No. A / 306

## SUMP PROTECTION PLATE

AUSTIN-HEALEY 3000

(BN. 7; BT. 7)

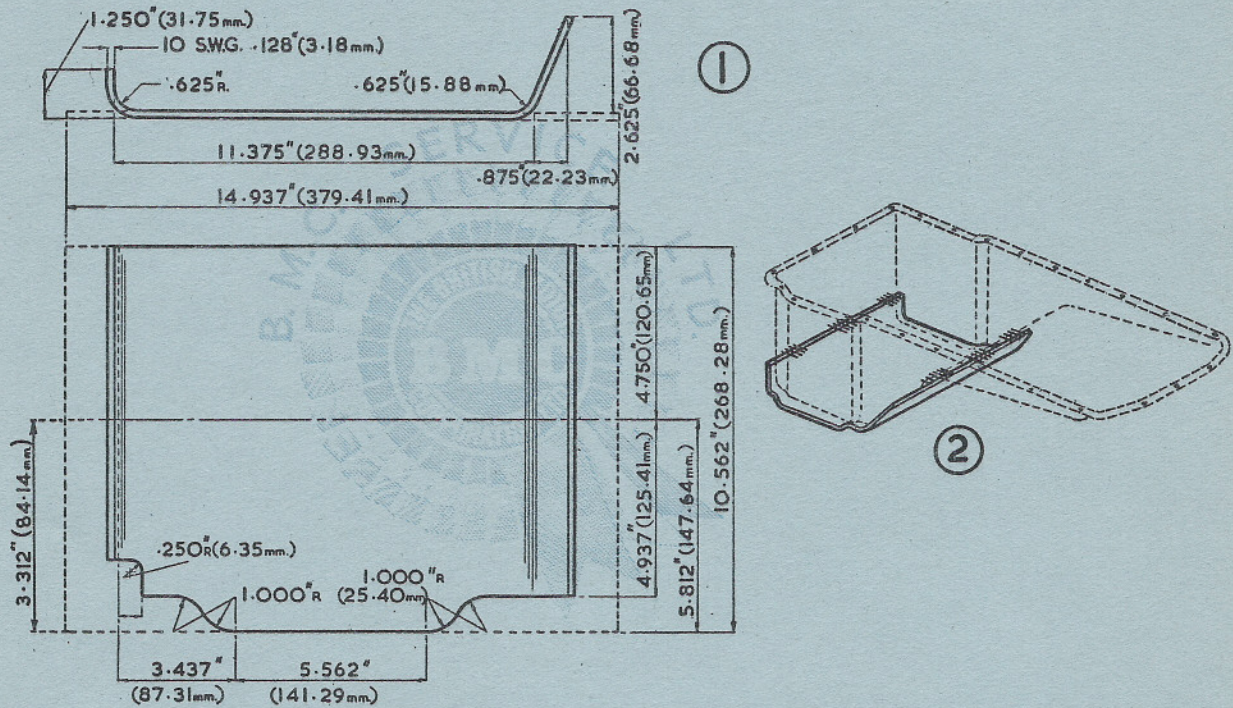
To prevent sump damage in very rough country, a mild steel protection plate (Fig. 1) may be welded to the sump in six places (Fig. 2)

Sumps should be drained and removed before welding. Arc-welding is preferable if distortion is to be avoided and Sifbronze will also enable a satisfactory job to be made.
